**From:** Warrior, Andrew  
**Sent:** 20 February 2020 14:13  
**To:** Kelsey Blain  
**Subject:** RE: Listed Building Consent and Planning Application for Mount Misery Farm, Hackness

Project  
Mount Misery Farm

Content  
Casement Window Details and Sections

Content  
Yorkshire Light Window Details and Sections

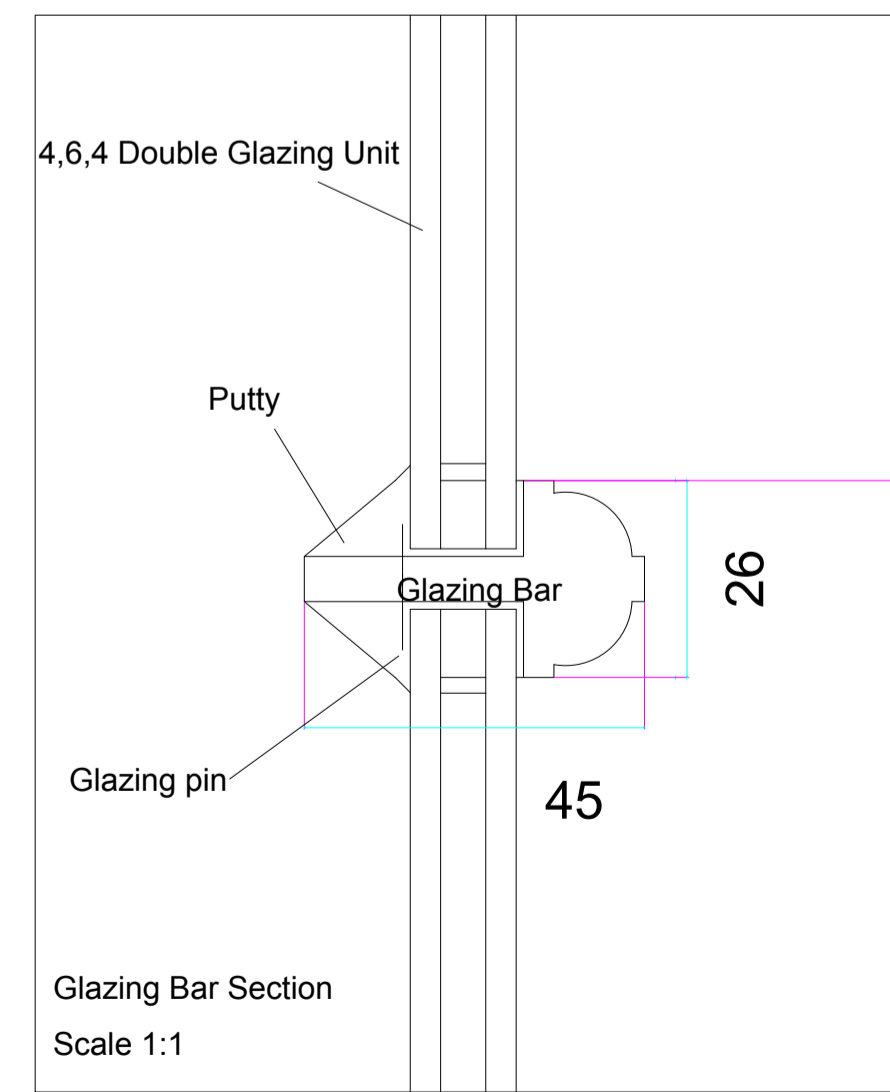
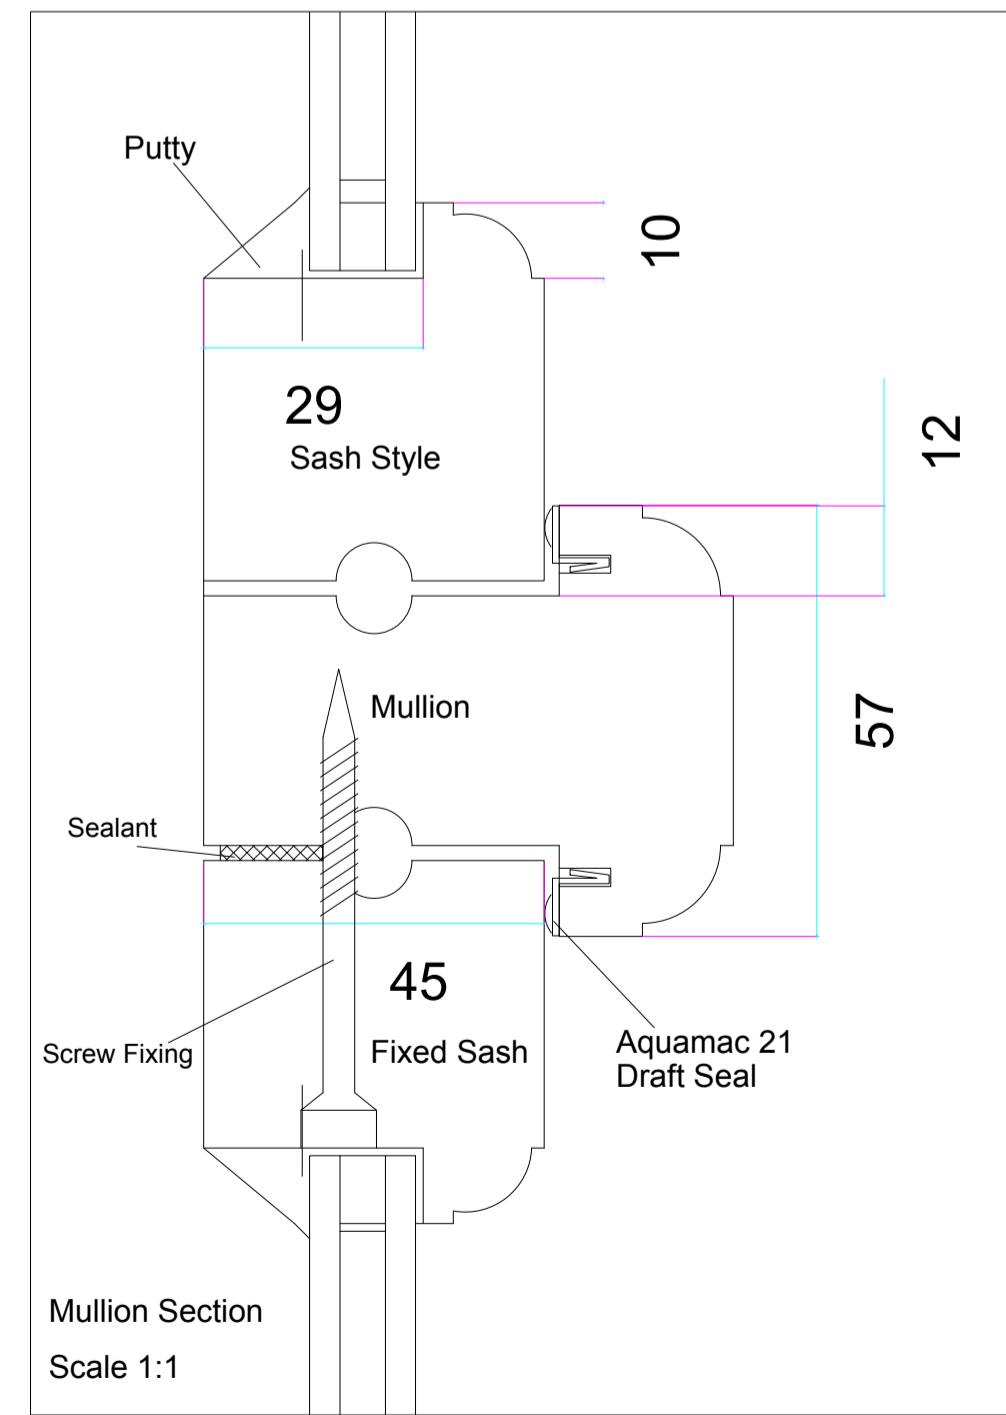
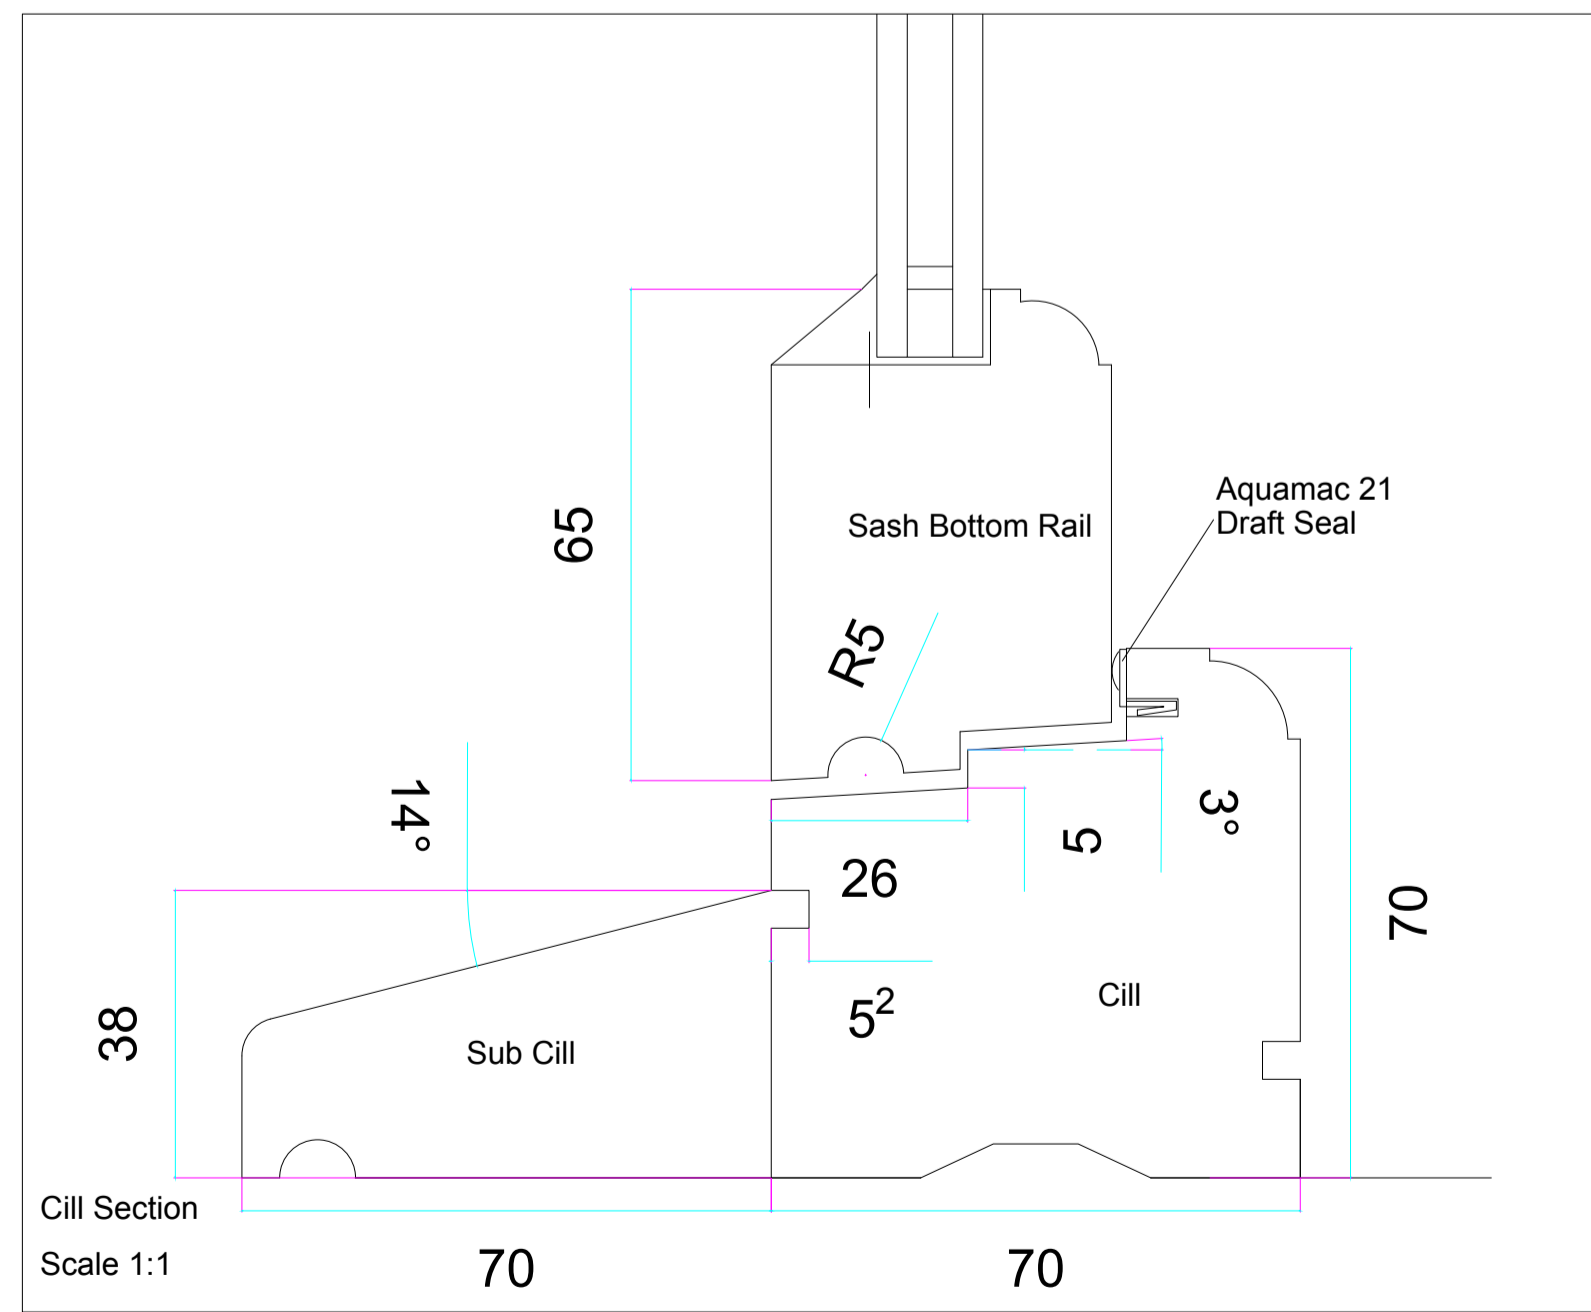
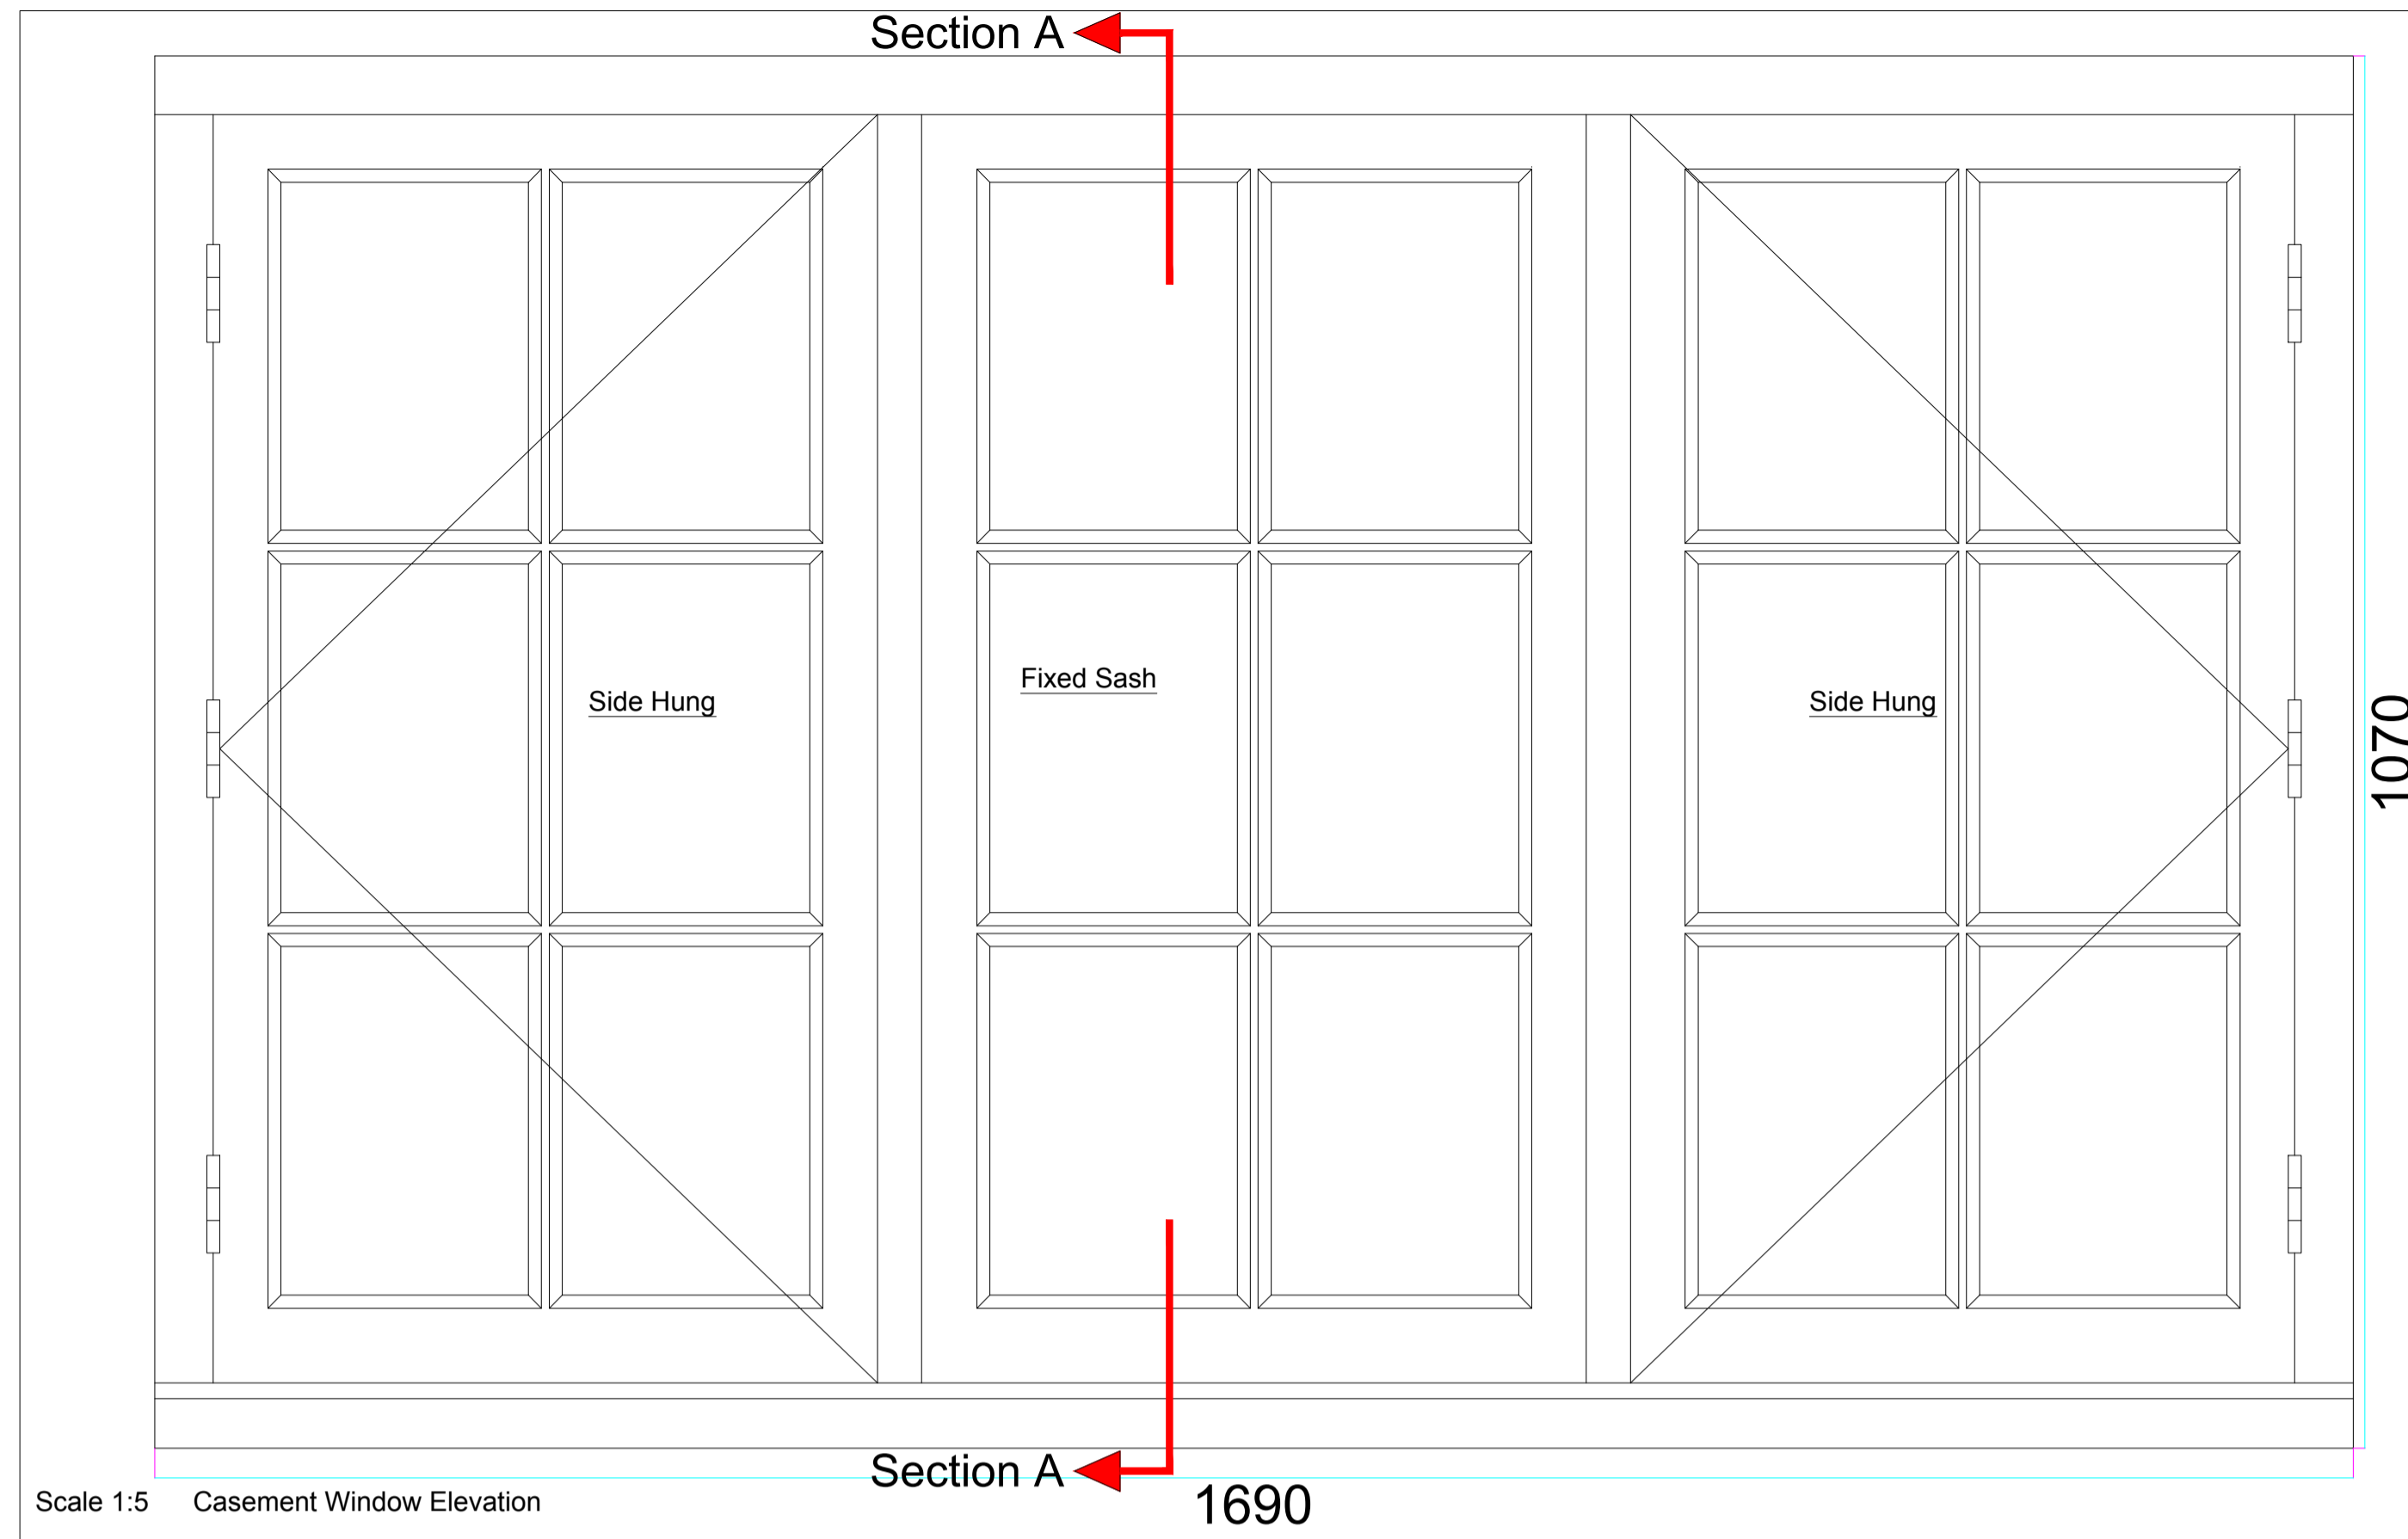
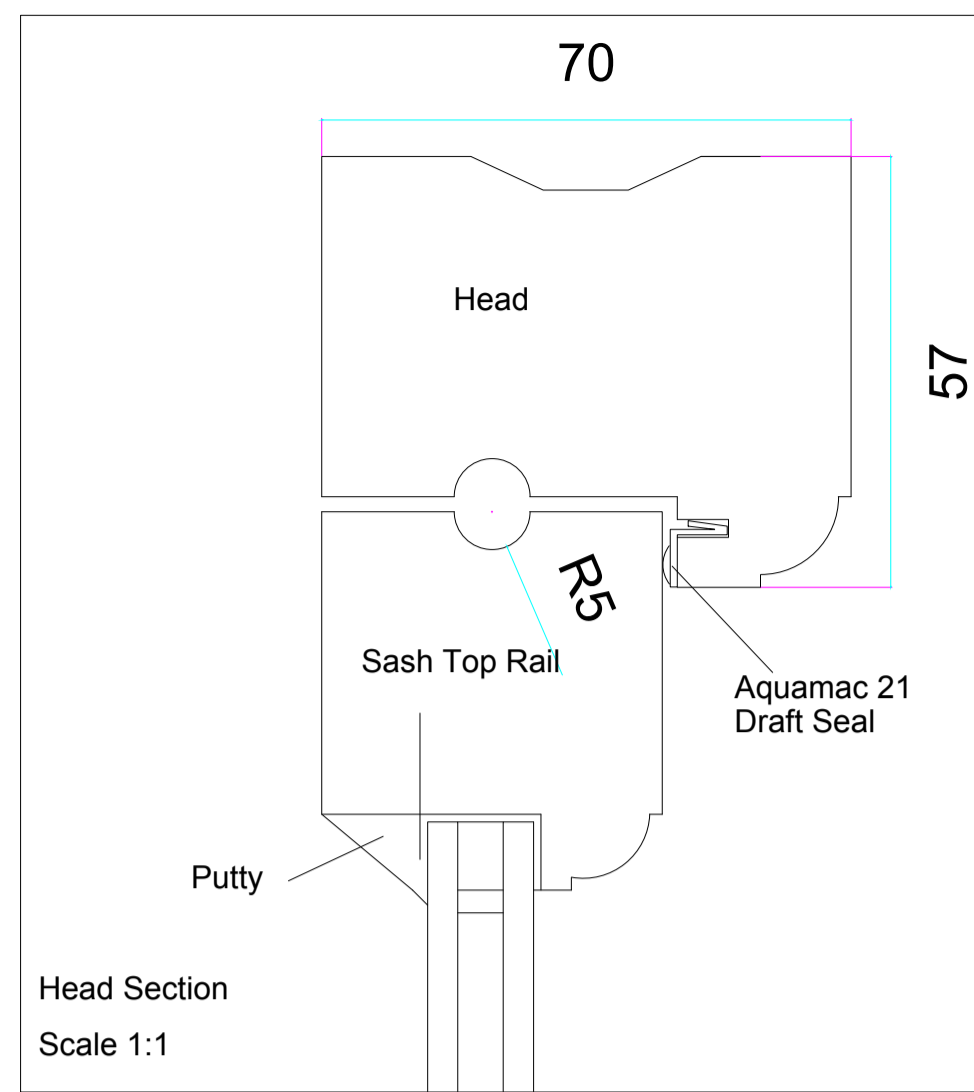
Furthermore, whilst we appreciate the casement window being amended to a fixed sash, may I request that the design of this sash be amended to replicate that of the sashes on either side. This will remove the thick transom from the central sash which is the non-traditional element within this window.

Caseament window:

- Omission of the central top opening section which isn't a traditional arrangement. Central pane should be fixed with just the two side panes opening.  
Top casement sash can be fixed

- Use of glazing putty to hold the glass, not beads. You can get putty which is compatible with d/g units.  
Although timber beading would be more suitable for double glazed units and the profile would look like putty as the timber beading in the photo you provided (Attached) I would be able to specify putty

- Reduction in the size of the glazing bar, down to 22mm if possible?  
As we are fitting double glazed units it would not be possible to reduce the size of the glazing bars. The double glazed unit spacing bar has a depth of 10mm, the rebate and the glass should have a 2mm clearance this is why the rebate depth has to be 12mm. When fitting beads to hold the unit in place the feather has to be sufficient to provide a secure fixing for the pins as you have requested putty the thickness of the feather is crucial to provide a safe and secure fixings.

- Omission of the drip moulds.  
The drip mould is good practise but will be removed
- Could consideration be given to use of a leaded cill, rather than a projecting cill – see example attached.  
The projecting cill is preferred as it will allow water to drain away from the building and prevent the water from traveling back in to the building by capillary action.

The kitchen window will remain as a casement window as drawings and the bedroom window will be changed to a Yorkshire light

I also omitted to say the casement windows will be hung on butt hinges and they will be held shut by traditional window stays and fasteners.
